# AGENDA

**June 21, 2012 Standards Committee Meeting**

REVISION TO INDIANA DESIGN MANUAL

REVISIONS TO VARIOUS SECTIONS OF THE INDIANA DESIGN MANUAL

Figure 409-2D  
(Page 1 of 4)

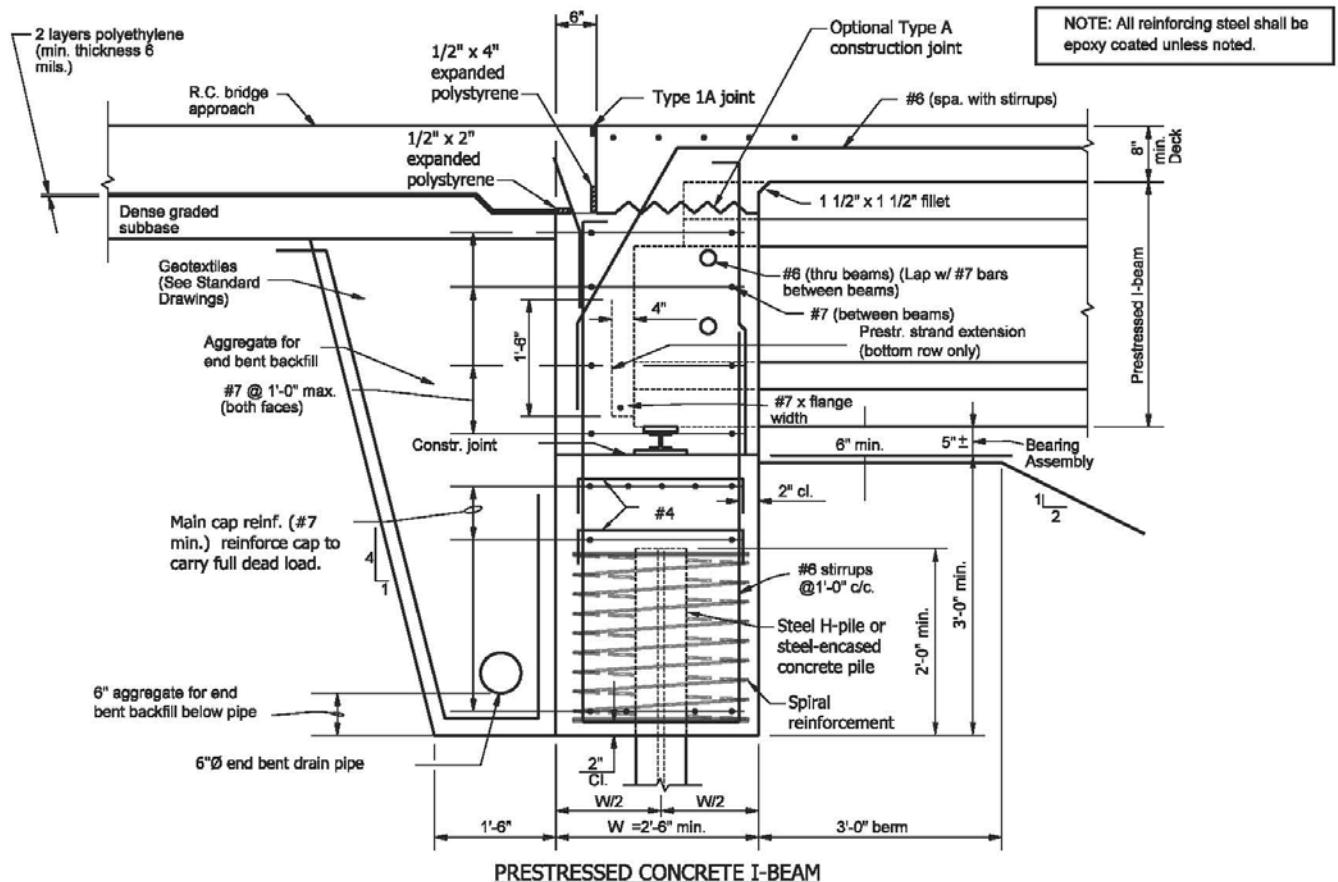
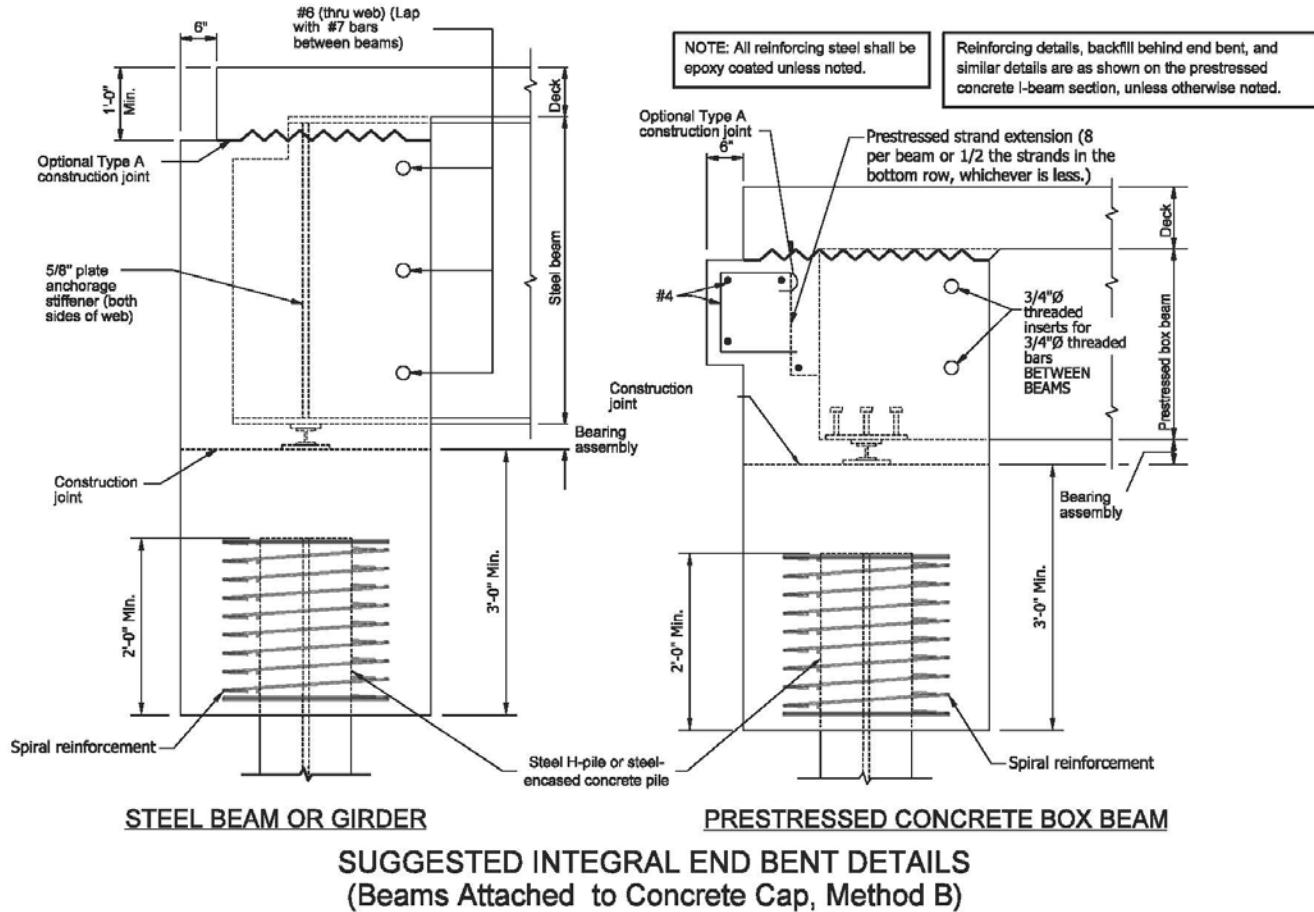
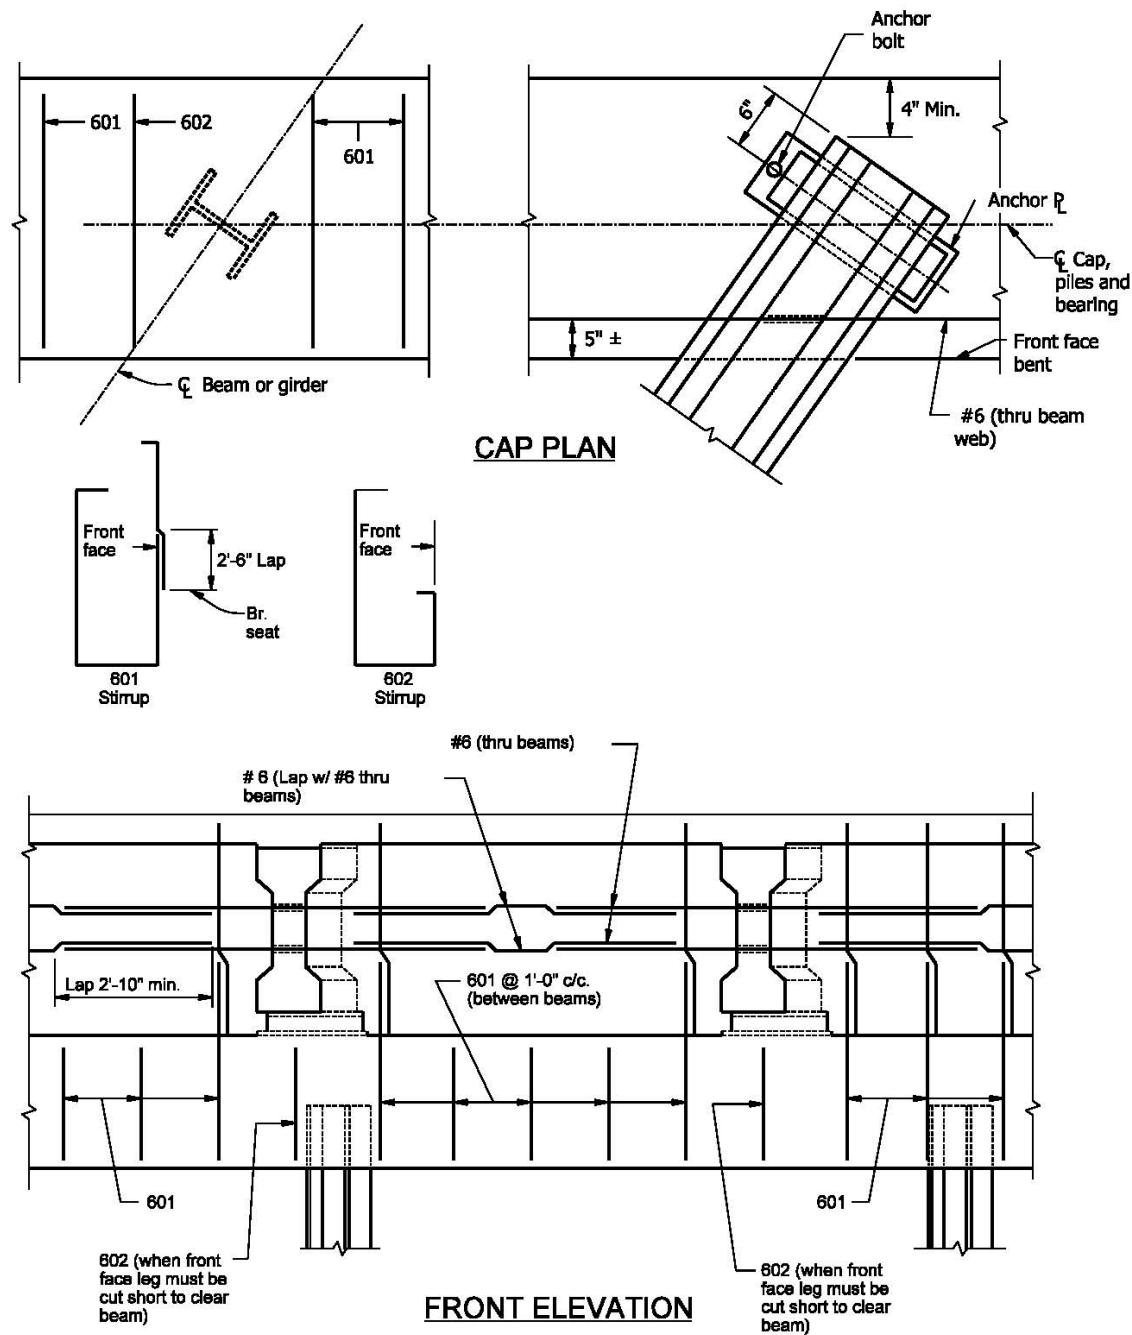
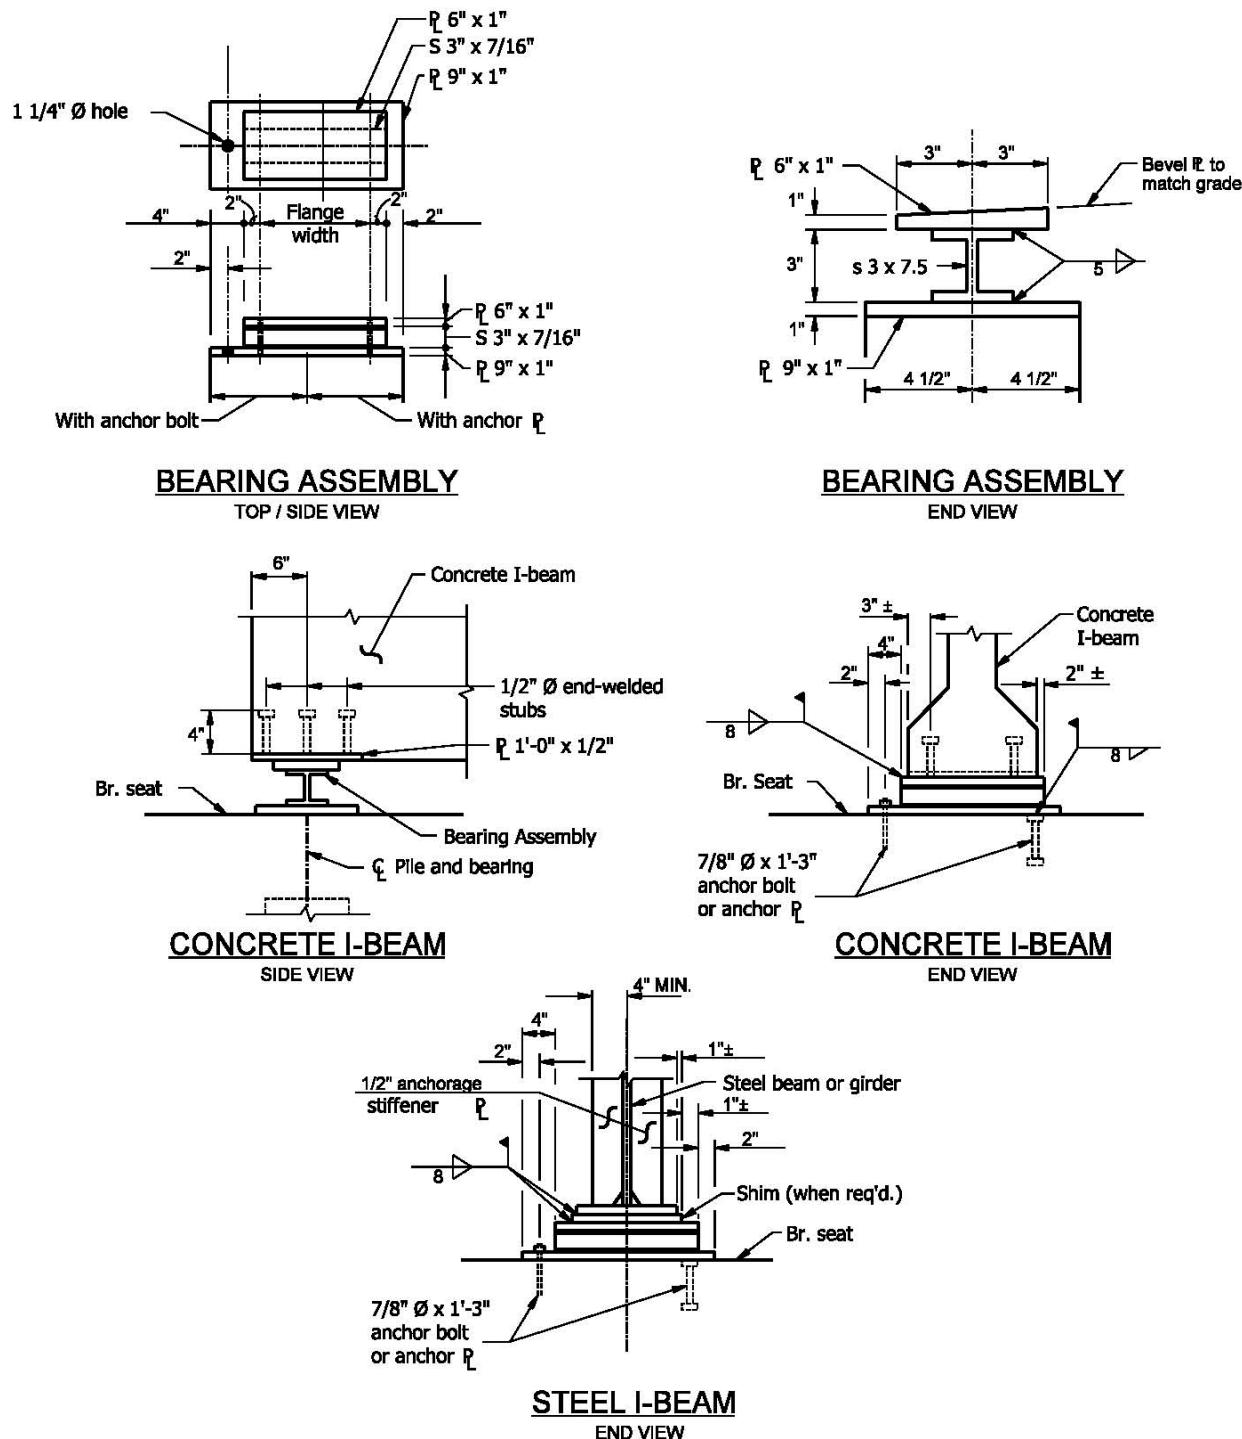
Figure 409-2A	Added new
Figure 409-2B	Added new
Figures 409-2C and -2D	Revised

An integral end bent may be constructed using either of the methods as follows (See Figures 409-2B and 409-2C).

Figure 409-2E

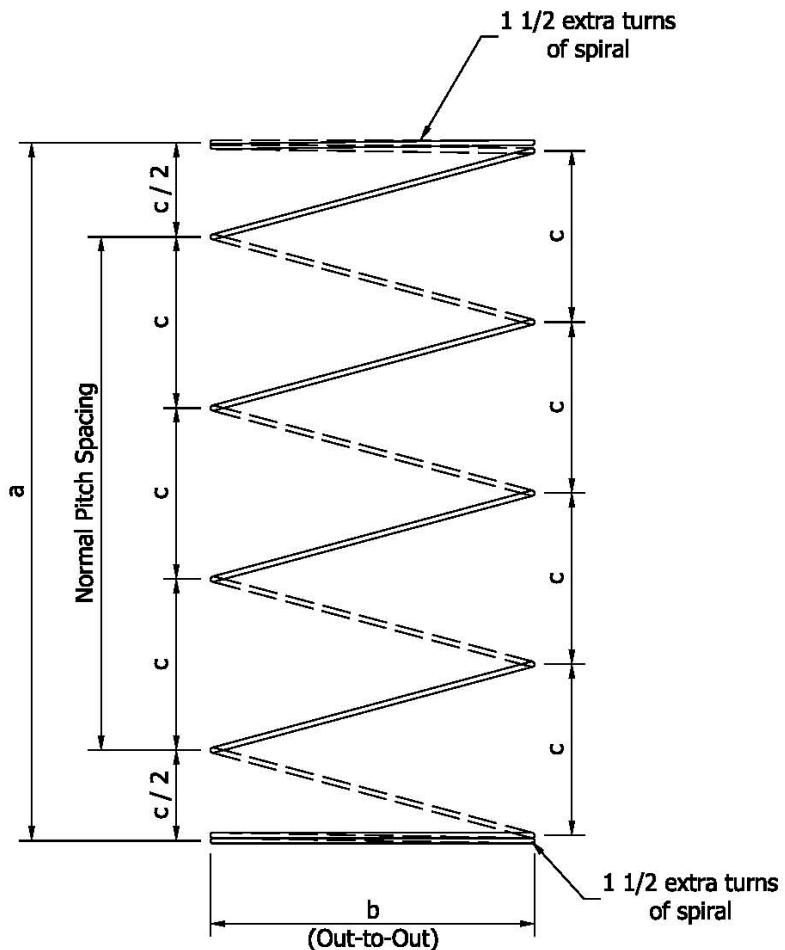
Figures 409-2E, -2F, and -2G	Added new
409-5.01	Reference to railroad track and crashwall has been deleted.
409-6.03(02)	Collision -static force revised from 400 kips to 600 kips.
409-6.03(03)	Reference to pier and location of the railroad track have been deleted.
409-7.03(03)	Rotation equations for the elastomeric bearing design have been deleted.
410-6.04(05)	Items 4 and 5 are revised. Figure relocated and reaction force for overturn was increased to two thirds from one-half.

TOOTH JOINT  
Figure 409-2F  
(Page 1 of 4)

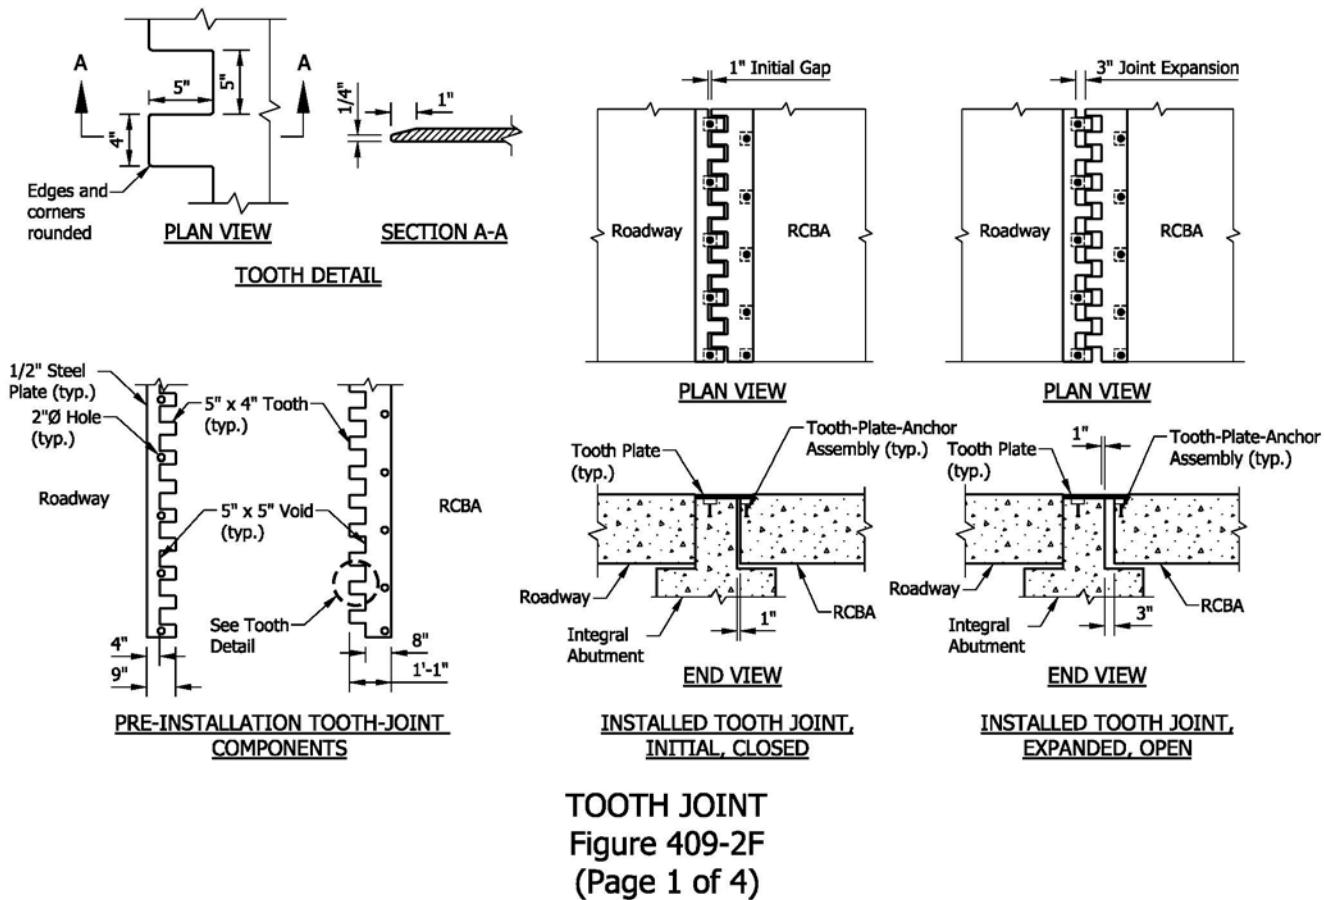
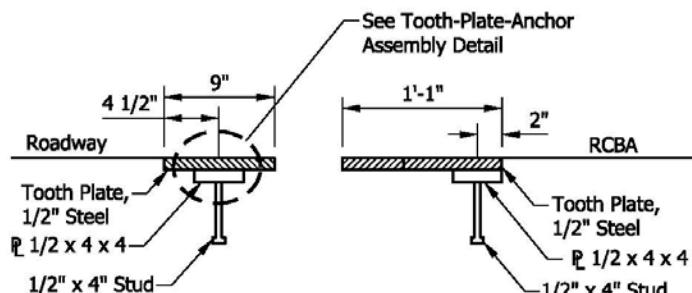
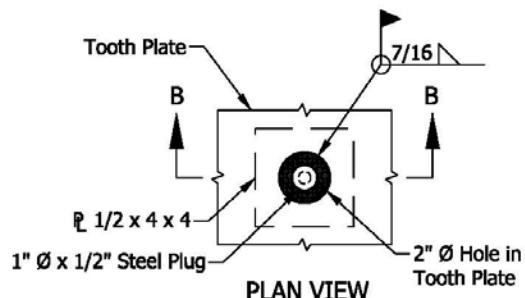
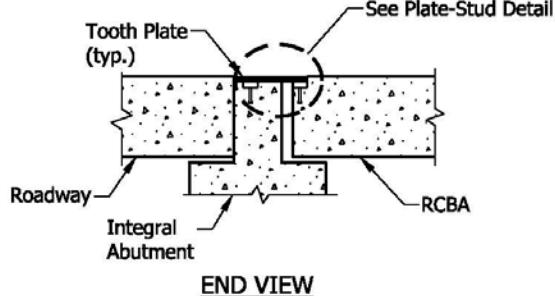
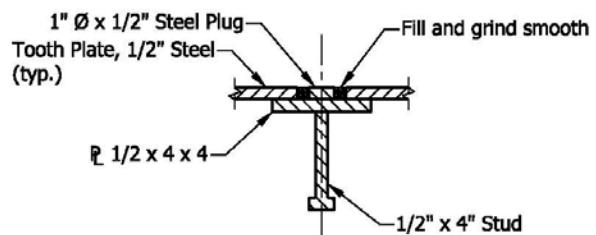
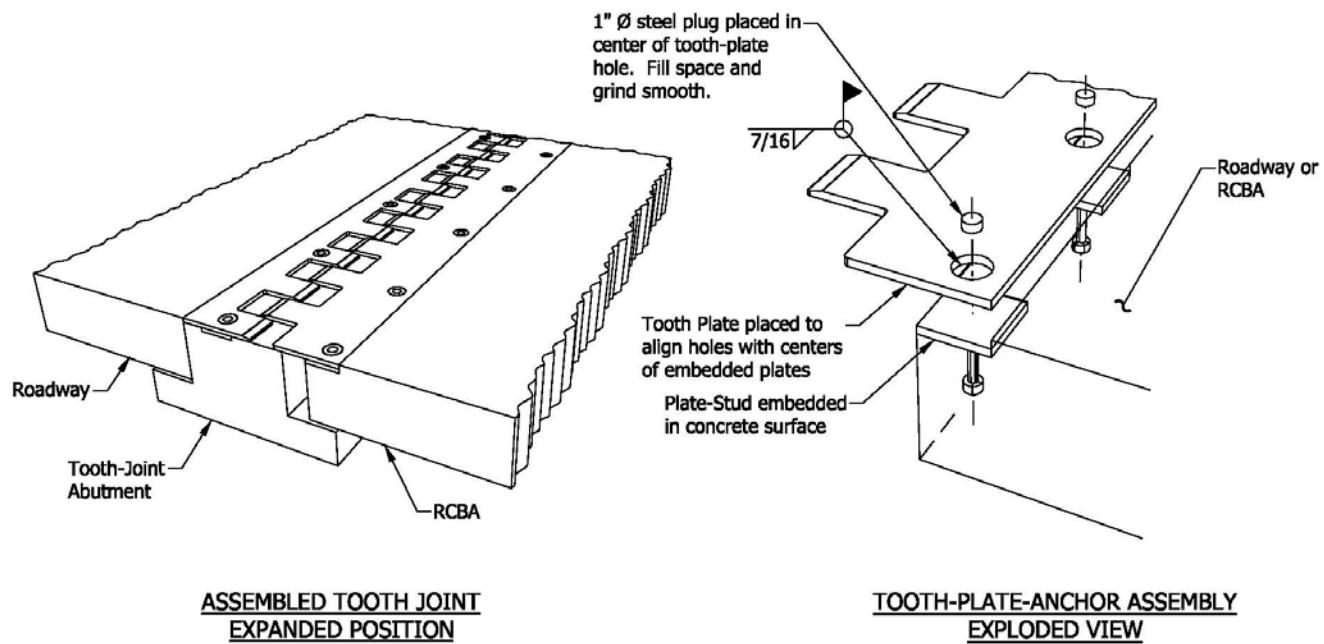
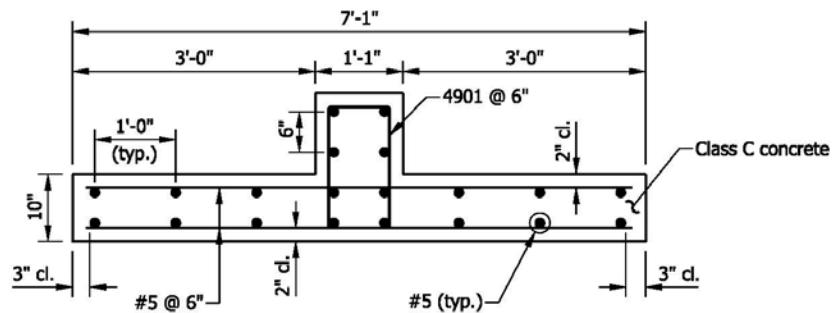
A recurring provision is proposed to support the plan details for this joint. It is proposed that the joint and the joint abutment be paid for per linear foot.

APPLICABLE DESIGN MANUAL SECTION: 409-2.04(02) item 3, and figure 409-2F
